Date: **November 30, 1998**

Subject: **EA BOARD ENHANCED RELIABILITY**

Model: **BVM-1915, BVM-1916**

Figure 1

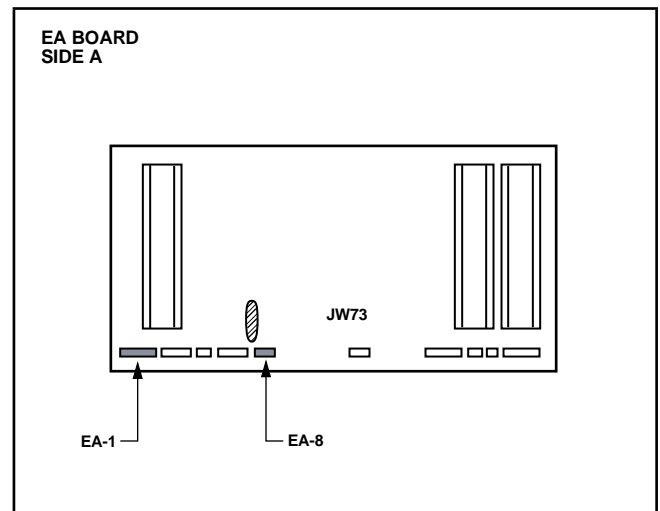
To enhance the reliability of the EA board (part number A-1345-881-A), replace jumper JW73 (+150V bus) on the board with a 0.47Ω carbon, non-flammable resistor as shown in Figure 1.

Part No.	Description	Qty.
1-249-443-11	Res, Carbon, 0.47Ω	1
